NEW FLANGE DESIGN AND MATERIAL

New Versions of Radial Piston Pumps Size
BRK501/502 & BRK1002

NEWS

New Versions of Radial Piston Pumps Size BRK501/502

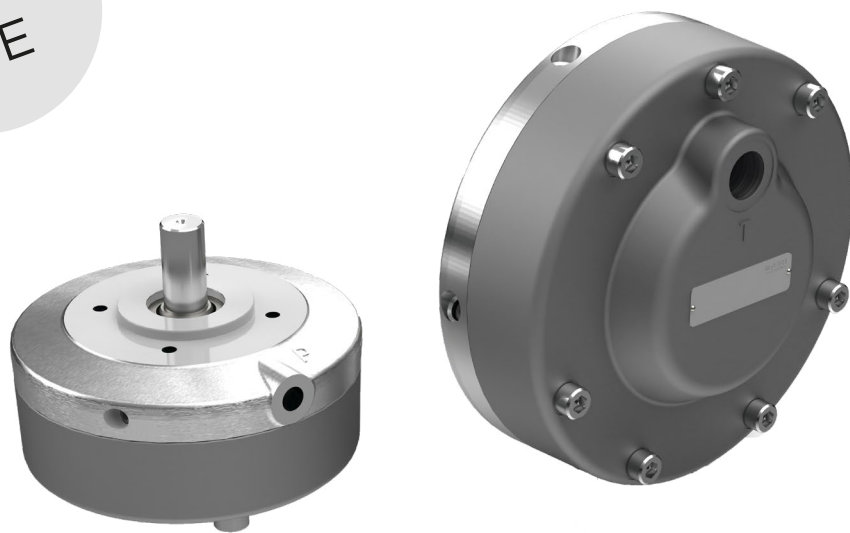
Flange material has been changed (aluminum → **steel**).

Changeover is already implemented.

Due to this change, some sizes of BRK501 pumps have been removed and has to be chosen from BRK701.

Dimensions and connections remain unchanged.

New Versions of Radial Piston Pumps Size BRK1002

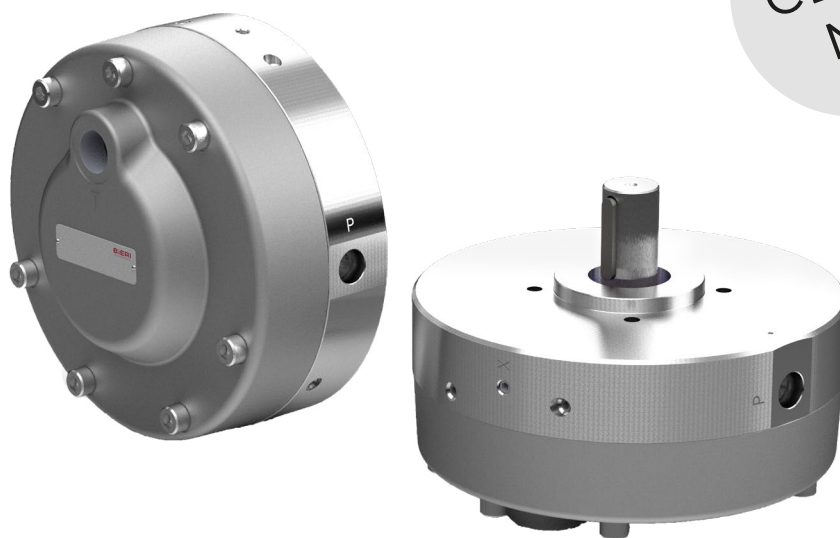
Flange dimension has been changed due to preparation of **Maximator connection** → officially approved for 1000 bar.

(**Adapters for Maximator, or G1/4"** connection as accessory)

Vent screw → perfect lubrication even for unfavourable situations of installation.

Size Adaptation from BRK12 to BRK1002

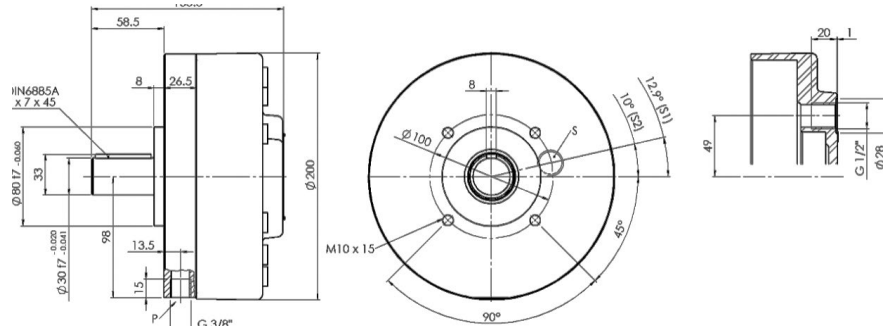
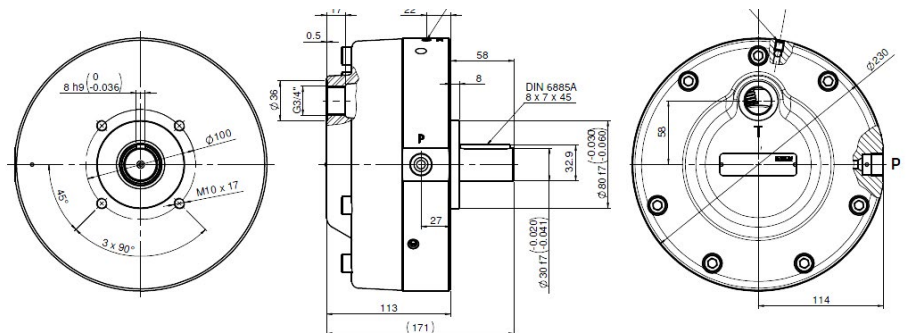
Design modification
